P-17047

28298

ISSUE-2

JINDAL ALUMINIUM LTD.
BANGALORE-560073 (INDIA)

NAME	DATE
DRAWN	J.P.KAUSHIK	23-09-2017
CHECKED		
APPROVED	B.NATARAJA	07-10-2017
SCALE		1:1
AREA mm ²		961.399
PERIMETER mm.		168.171
WEIGHT kg/m		2.596
DRAWING No.	SECTION No.	
P-17047	-	
28298	28298(ISSUE-2)

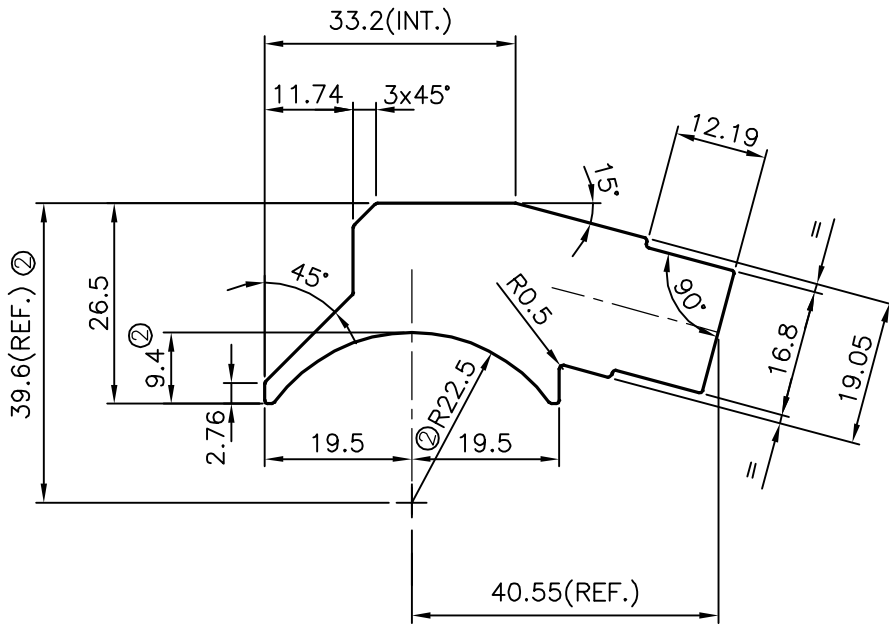
DIMENSION CHANGED FROM 31.5 TO 39.6, FROM 12 TO 9.4 & RADIUS CHANGED FROM 17 TO 22.50 mm

WEIGHT ALSO CHANGED FROM 2.473 TO 2.596 kg/m
